# Bakersfield City School District

March 26, 2024

To: Interested Classification A & C-12 Contractors  
Re: Eissler - Asphalt Replacement, Fencing & Install of Basketball & Tetherball Poles Project

## Addendum 1

# Attachment "A" Site Information (Eissler Elementary)

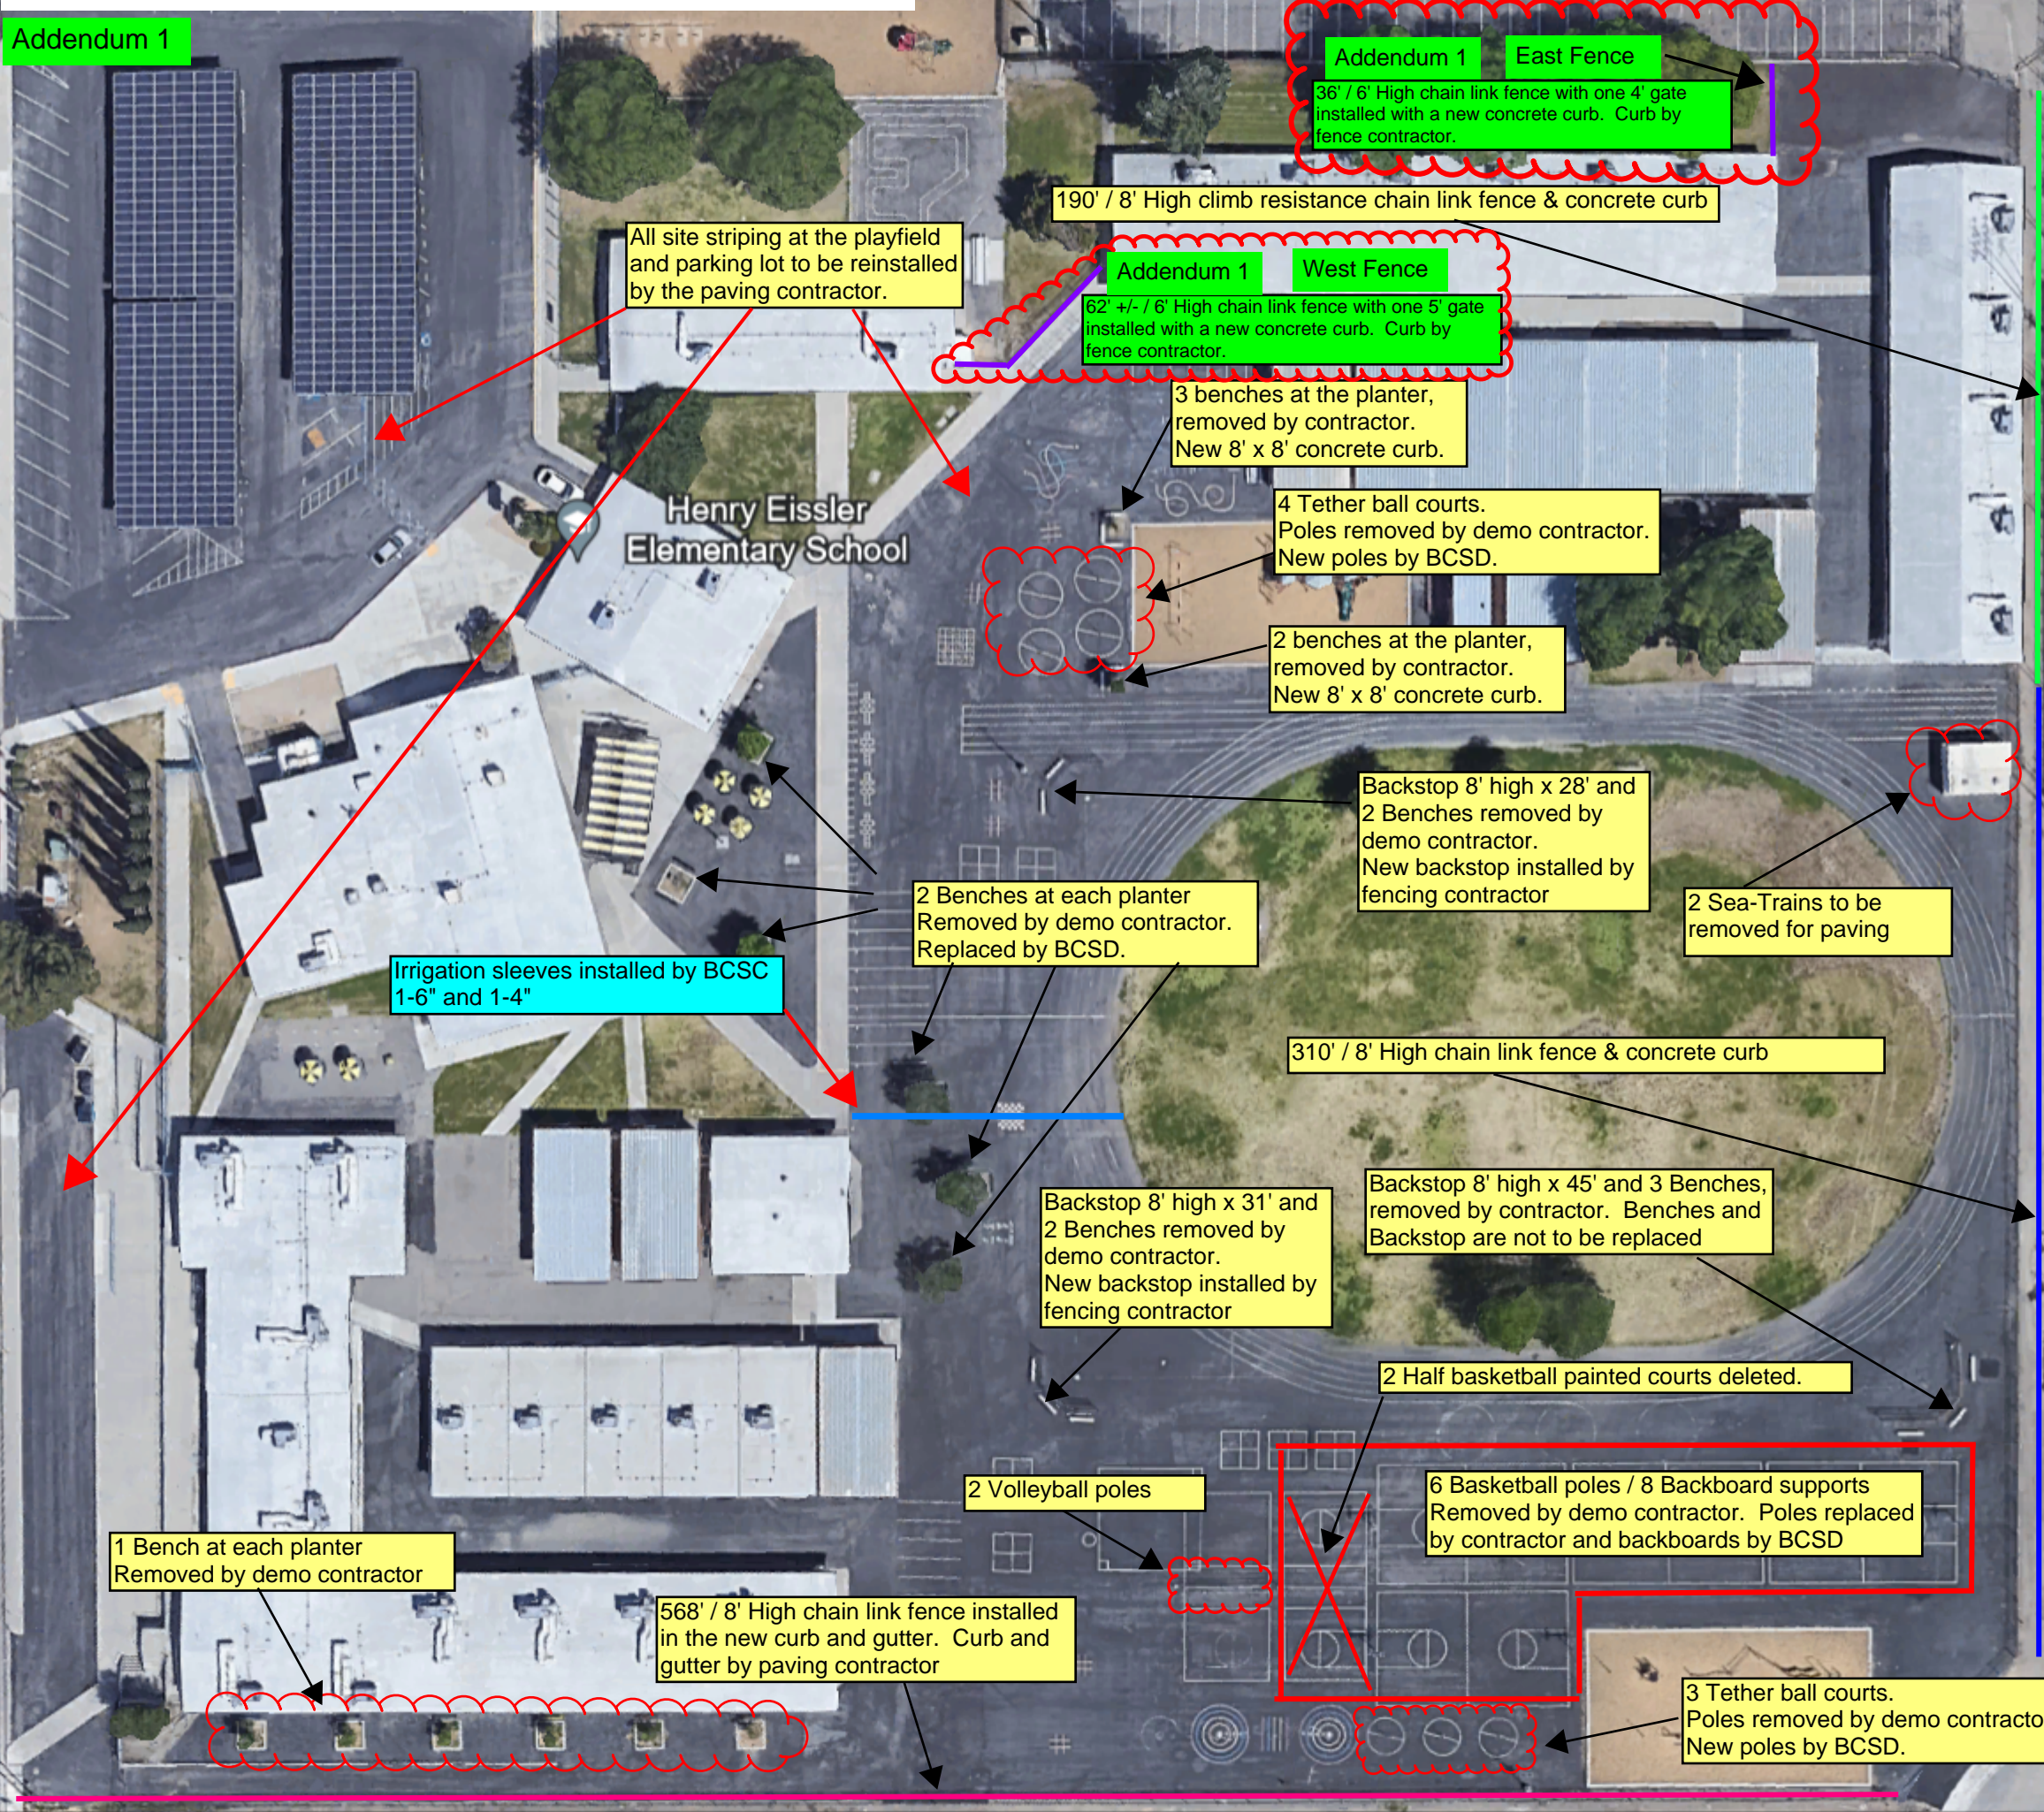
6. Bid Package 03 - Add volleyball pole installation. Poles supplied by BCSD. See addendum notes on Attachment A.
7. Bid Package 01 – Two 8' x 8' concrete curbs are shown on Attachment A. The curbs are to be 18" above grade 10" wide and 6" into native soil.

8. Additional chain link fence at two locations. See addendum notes on Attachment A.
  - West Fence:
    - Bid Package 01 Demo existing 6' high x approximately 73' long chain link fence with an 8' gate.

- Bid Package 02 Install 6' high x approximately 73' long chain link fence with an 8' gate, including 10" wide x 7' deep concrete curb flush with the existing sidewalk.

- East Fence:
    - BCSD to remove temporary fencing.
    - Bid Package 02 Install 6' high x approximately 36' long chain link fence with a 4' gate, including 10" wide x 7' deep concrete curb flush with the existing landscape grade.

9. South Fence
  - Bid Package 02 No temporary fence required.
  - Bid Package 02 Include new gates on the west end of the south fence.

**Addendum 1 Alternate 1**

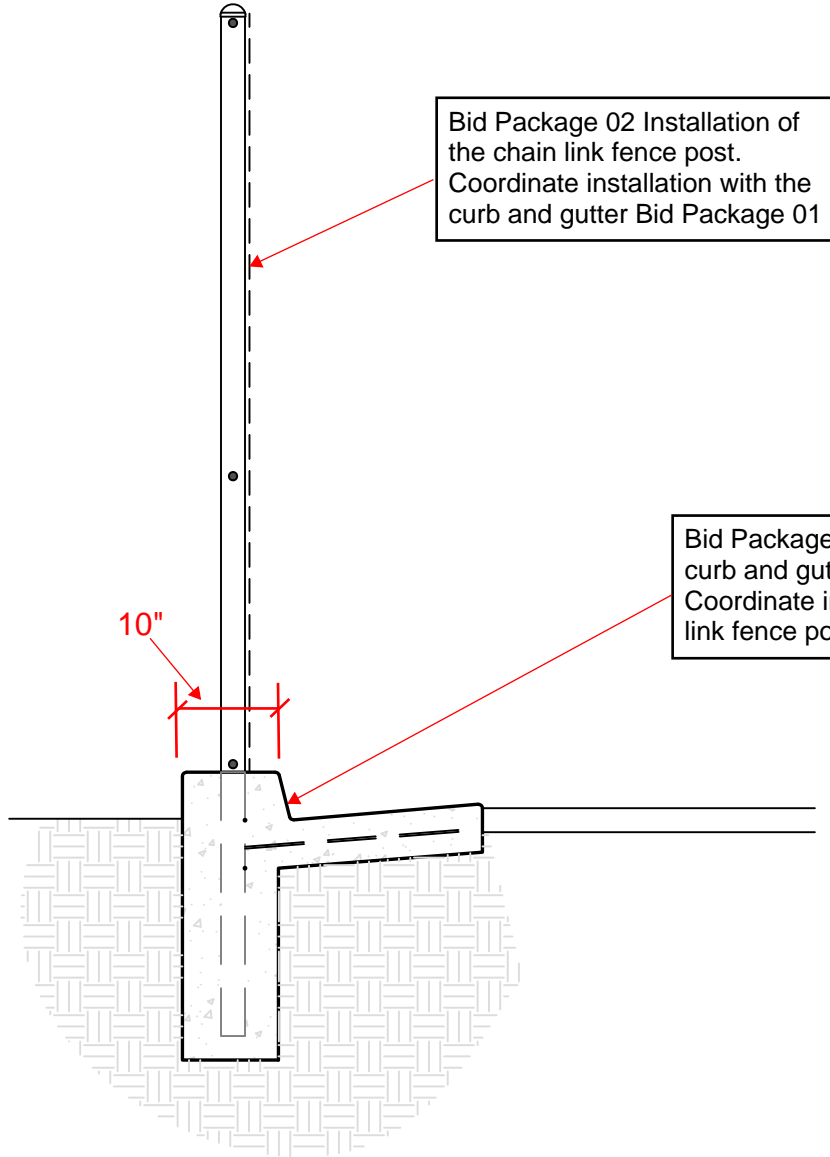
- Alternate 1 (Installation of Curb & Gutter at the south fence line including chain link fence post to be installed in the concrete curb and gutter)
  - Bid Package 02 Installation of the chain link fence post. Coordinate installation with the curb and gutter Bid Package 01
  - Bid Package 01 Installation of the curb and gutter. Coordinate installation of the chain link fence post with Bid Package 02

Bid Package 02 Installation of the chain link fence post. Coordinate installation with the curb and gutter Bid Package 01

Bid Package 01 Installation of the curb and gutter. Coordinate installation of the chain link fence post with Bid Package 02

10"

**Addendum 1 Alternate 2**

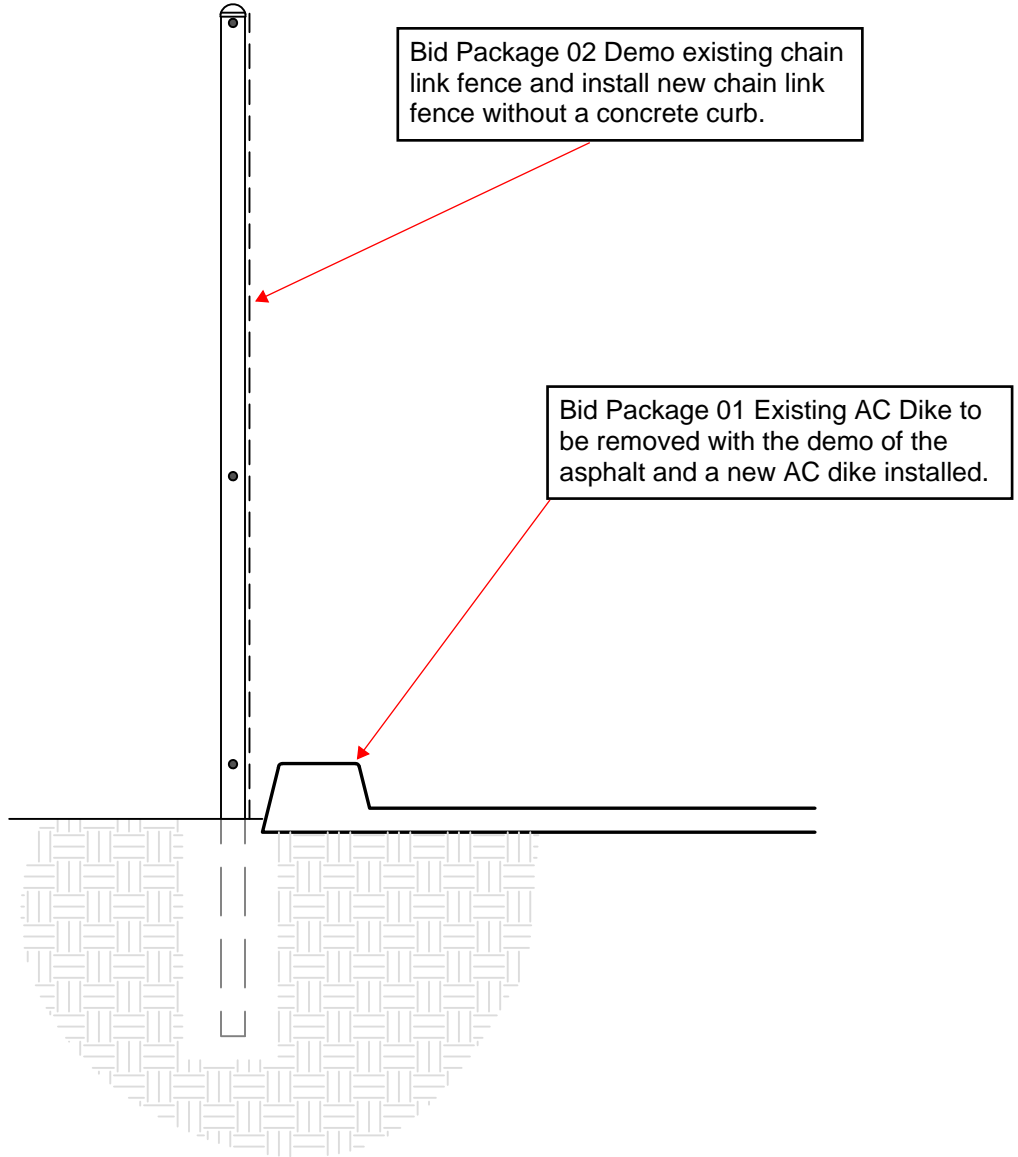
- Alternate 2 (Installation of chain link fence at the south fence line, no concrete curb. Removal of existing AC Dike and Installation of new AC Dike)
  - Bid Package 02 Demo existing chain link fence and install new chain link fence without a concrete curb.
  - Bid Package 01 Existing AC Dike to be removed with the demo of the asphalt and a new AC dike installed.

**Addendum 1 Alternate 3**

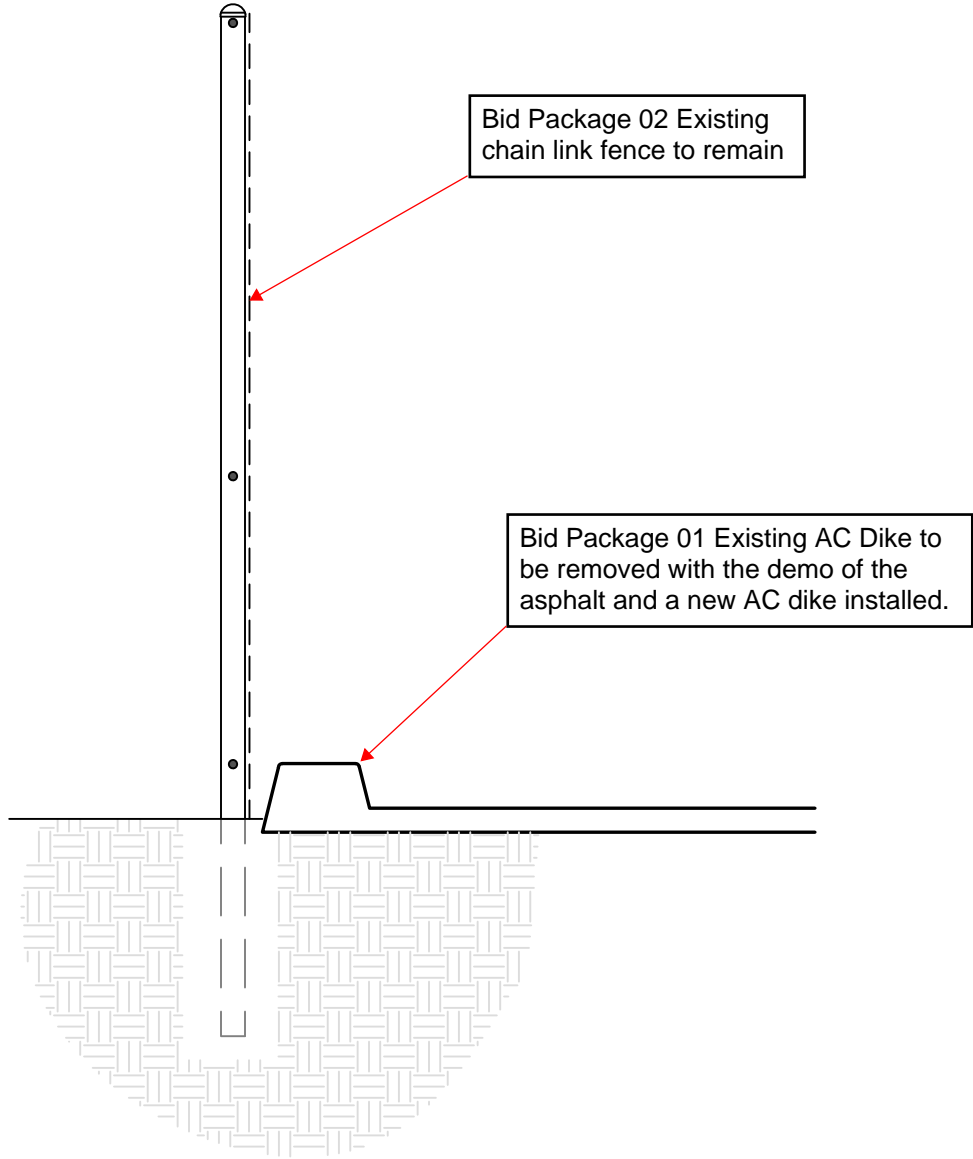
- Alternate 3 (Installation of chain link fence at the south fence line to be eliminated. Removal of existing AC Dike and Installation of new AC Dike)
  - Bid Package 02 Existing chain link fence to remain.
  - Bid Package 01 Existing AC Dike to be removed with the demo of the asphalt and a new AC dike installed.
